3. Corrections and Additions

As required by Section 15088(d) of the CEQA Guidelines, this chapter provides corrections or clarifications to the Draft EIR. None of the corrections and additions constitute significant new information or substantial project changes, as defined by Section 15088.5 of the CEQA Guidelines, and thus, recirculation of the Draft EIR is not required. The changes to text and graphics contained in the Draft EIR are indicated below under the corresponding Draft EIR section heading. Deletions are shown in strikeout text and additions in underlined text.

Page 3.2-5 – Revised Figure 3.2-1 Landscape Unit Overview as follows:

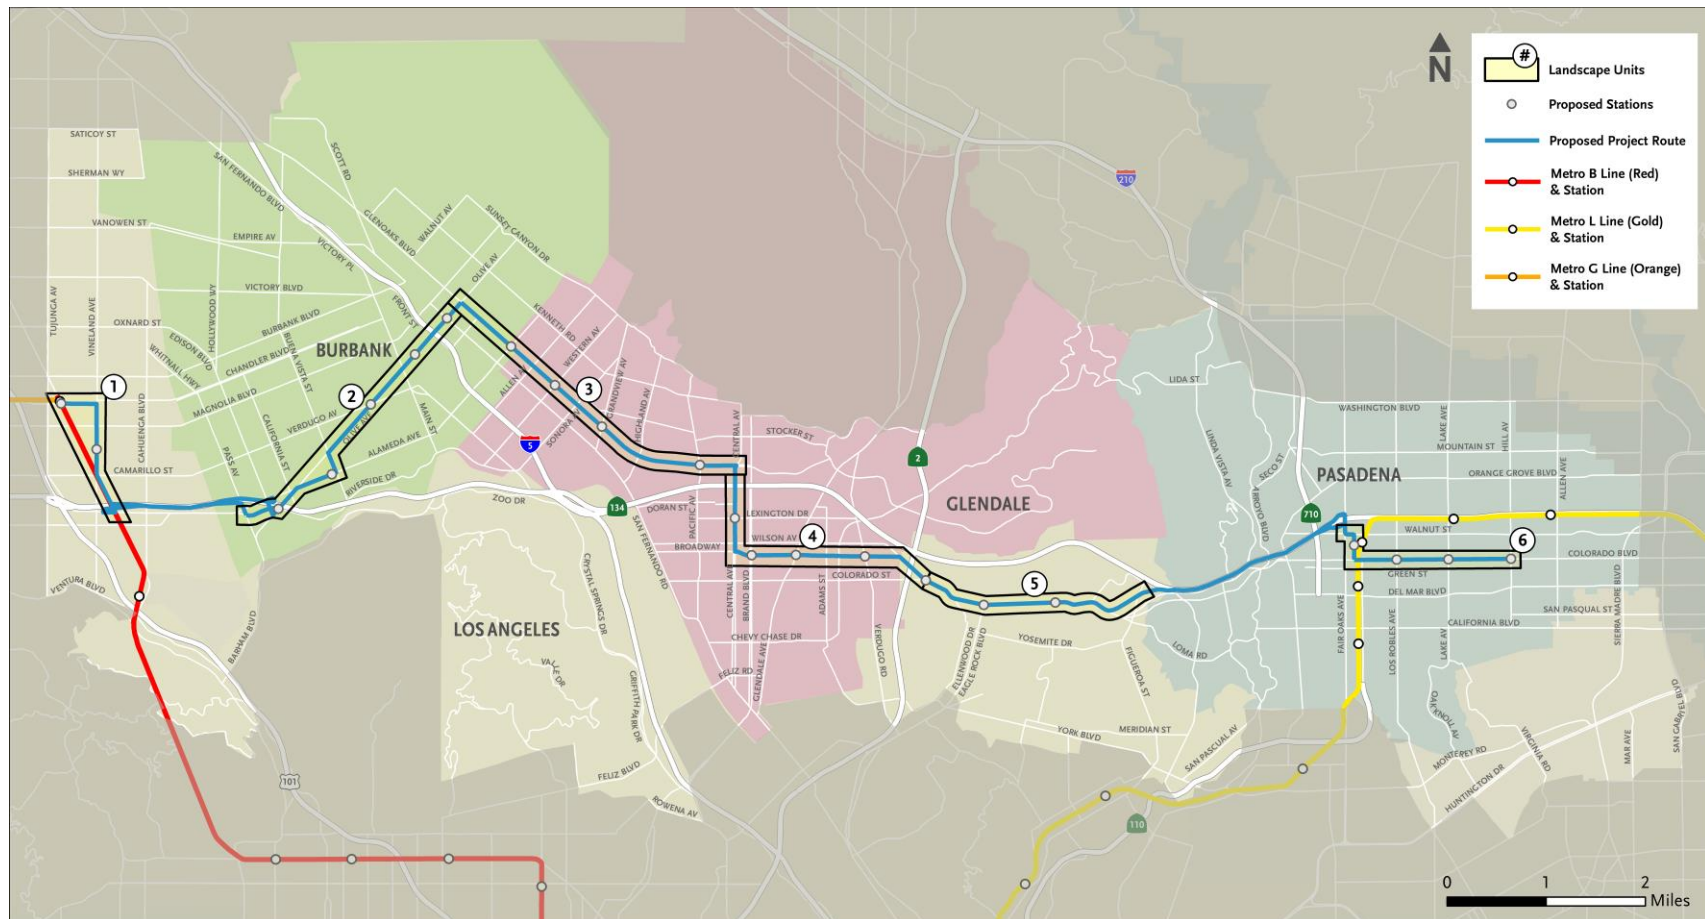
Page 3.2-4, last paragraph – delete references to route options as follows:

To illustrate the existing visual setting, representative landscape units (LUs) were selected to provide a summarized description of the visual character and quality of the Project Area as well as an account of visual resources present. An LU is a portion of the regional landscape and can be thought of as an outdoor room that exhibits a distinct visual character. The LUs were selected based on geographic and jurisdictional divisions along the route ~~and route options~~ with a focus on the visual consistency among development patterns, visual resources, and overall character. Each LU is delineated on maps and numbered from LU-1 to LU-6. **Figure 3.2-1** provides an overview of the LUs

Page 5-4 – Revised Figure 5-1a – Related Projects as follows:

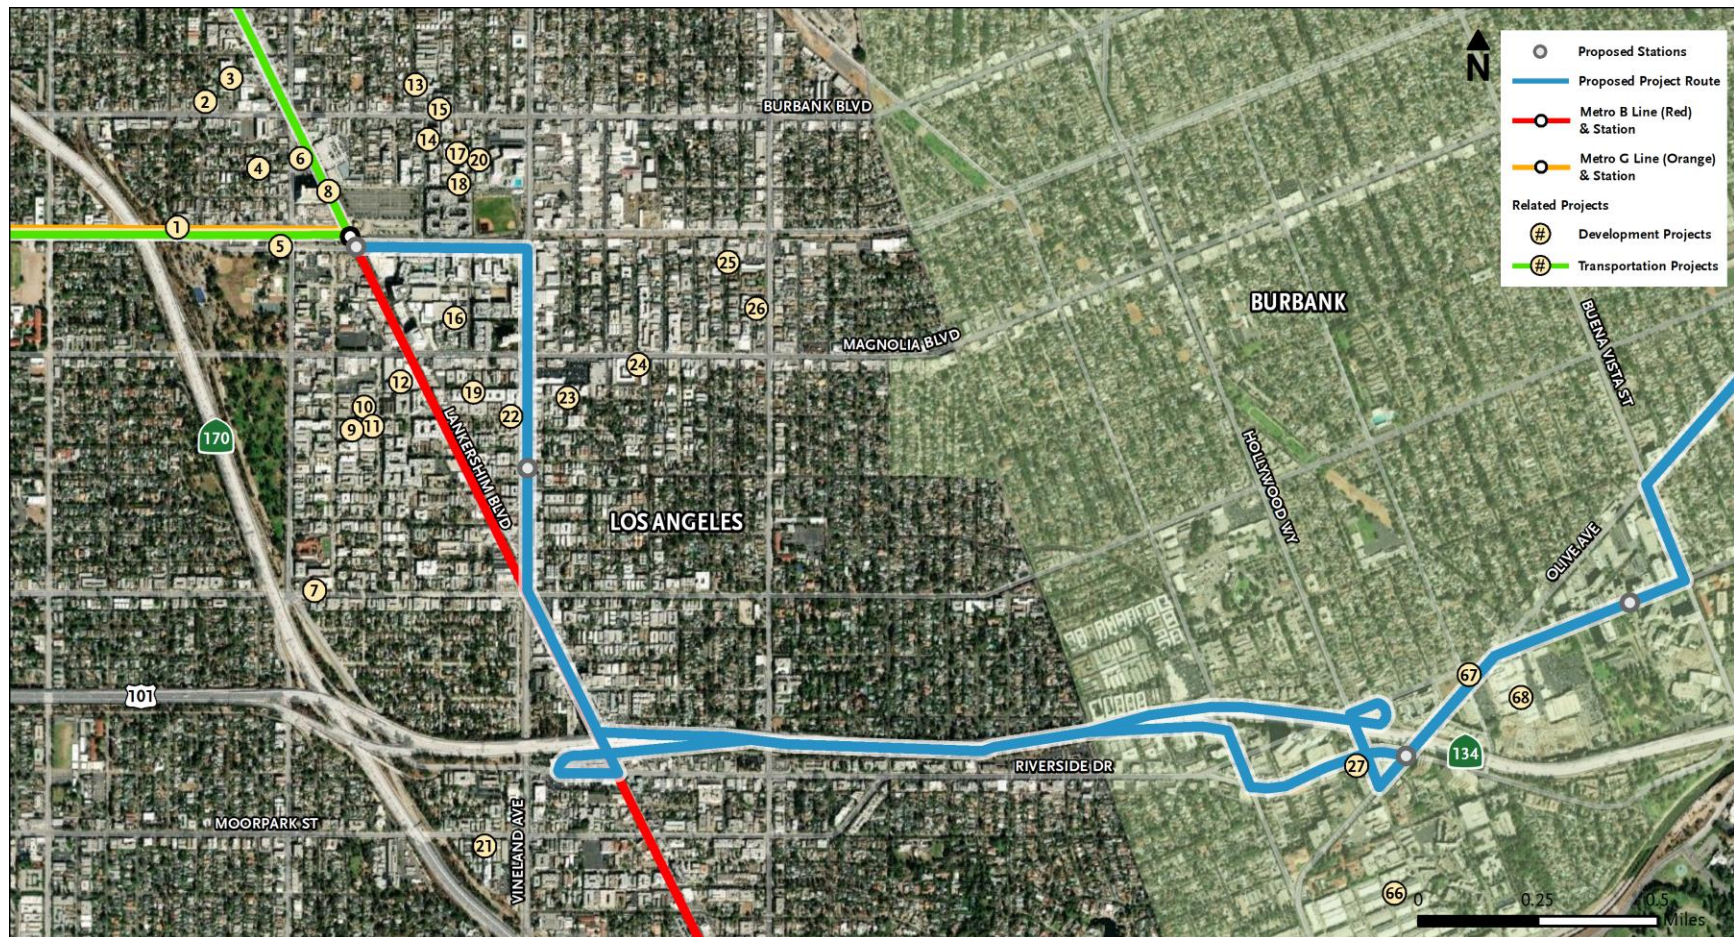
Page 5-7 – Add the following projects to **Table 5-2**:
